This page lists the know errors on the gm5x5x5 PCBs. There are no known issues with the bulk order run (white pcbs), the following information is valid **only** for the prototype run (green pcbs).

Bulk Order #1 (white PCBs, rev 1.0)

Prototype Run (green PCBs)

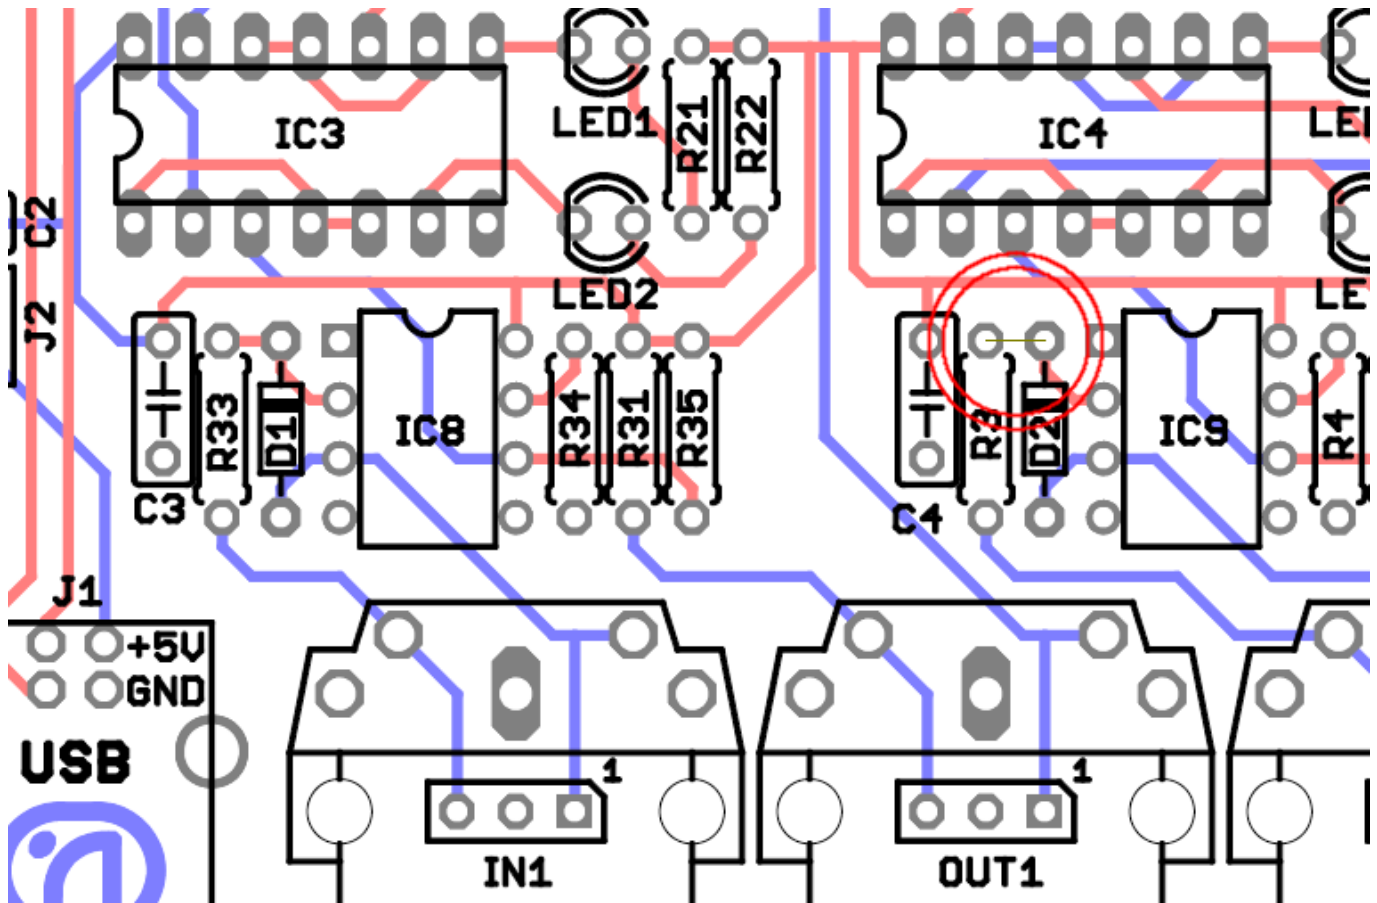
Problem: The MIDI IO pins of the midi sockets (Pin 4 + 5) are switched.

Problem: A track between D2 and R3 is missing.

Solution: Either (1) use the pin-headers if you use sockets that are not mounted on the pcb or (2) break the traces to pins 4 + 5 of the sockets and solder wires to them or (3) solder the midi sockets on the other side of the pcb.

Solution: Bridge the pins.
